National Committee on **Uniform Traffic Control Devices**

National Committee on Uniform Traffic Control Devices (NCUTCD) Recommended Changes to Proposed Text for 11th Edition of the MUTCD Docket Number: FHWA-2020-0001

Federal Register Item Numbers: 582-585

NPA MUTCD Section Numbers: Chapter 9A.01-9A.08 **Legend:** Base text shown in proposal is the NPA "clean" proposed text. NCUTCD recommendation for text to be added in final rule.

Figure 9A-1. Sign Placement on Shared-Use Paths

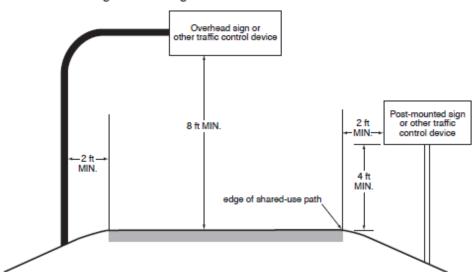
NCUTCD agrees with Figure 9A-1 in the NPA.
